Notice of Intent

Type of Action: APD Change

**Procedure Description:** XTO respectfully requests approval to make the below listed changes to the approved APDs. 1. Casing design to be changed from the “4-String Design – Engineered Weak Point” (FIGURE F) to the “4-String Design – Open 1st INT x 2nd INT Annulus” (FIGURE D). An open annulus will be utilized and monitored during completions operations. Post completion, bradenhead squeeze will be performed to tie back the 1st intermediate x 2nd intermediate annulus. TOC will be placed into the 1st intermediate shoe but still below the base of Potash interval. 2. No changes to the cementing, casing or mud circulating system designs will be required for the requested change. 3. There is no new surface disturbance. Please refer to the R-111-Q well bore diagrams in the attachment reflecting the changes requested. WELL NAME API Number JRU Apache Federal Com 114H 30-015-55830 JRU Apache Federal Com 115H 30-015-55831 JRU Apache Federal Com 804H 30-015-55853 JRU Apache Federal Com 904H 30-015-55858 JRU Apache Federal Com 709H 30-015-56190 There is no new surface disturbance.

James\_Ranch\_Unit\_Apahe\_\_Pad\_C\_\_Sundry\_Blanket\_request\_fr

**Previous Design: 4-String Design – Engineered Weak Point****[Figure F] 4 String – 2<sup>nd</sup> Intermediate casing engineered weak point**

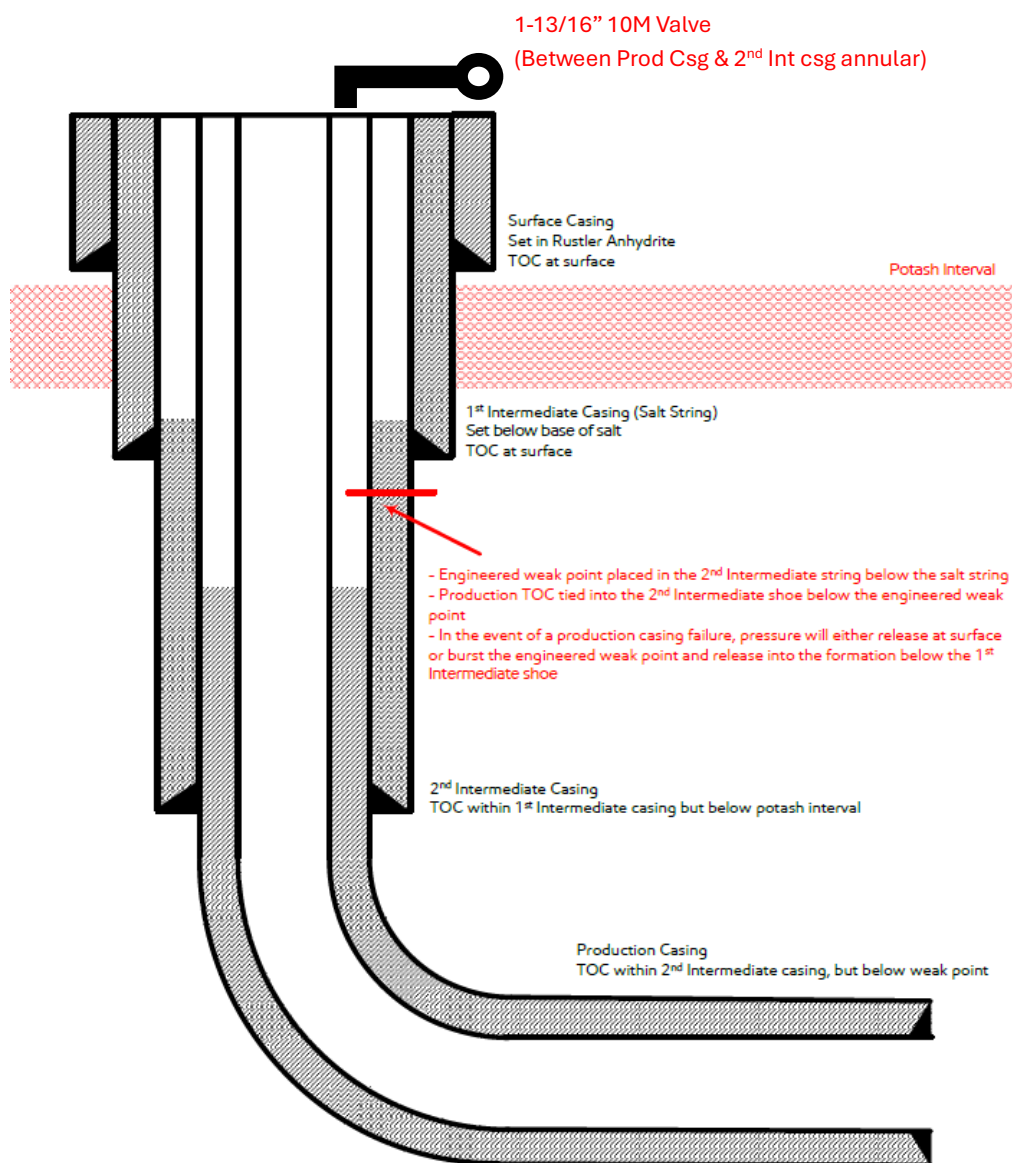
1. Casing design to be changed from the "4-String Design – Engineered Weak Point" (FIGURE F) to the "4-String Design – Open 1<sup>st</sup> INT x 2<sup>nd</sup> INT Annulus" (FIGURE D). An open annulus will be utilized and monitored during completions operations.

Post completion, bradenhead squeeze will be performed to tie back the 1<sup>st</sup> intermediate x 2<sup>nd</sup> intermediate annulus. TOC will be placed into the 1<sup>st</sup> intermediate shoe but still below the base of Potash interval.

2. No changes to the cementing, casing or mud circulating system designs will be required for the requested change.

- 1) Alignment with KPLA requirements per schematic per schematic below, with engineering weak point casing design and utilizing new casing that meets API standards.
- 2) Contingency plans in place to divert fluids away from salt interval in event of production casing failure.
- 3) Intermediate 2 casing will consist of a primary cement job with TOC at the top of the Brushy Canyon formation within the Delaware Mountain Group.
  - a. Bradenhead squeeze to be completed after primary cement job to tie back TOC to intermediate 1 "Salt string" at least 500' but with top below Marker Bed 126 "Potash Interval".
- 4) Production cement to be tied back no less than 500' inside previous casing shoe (intermediate 2 casing) and below the engineered weak point.
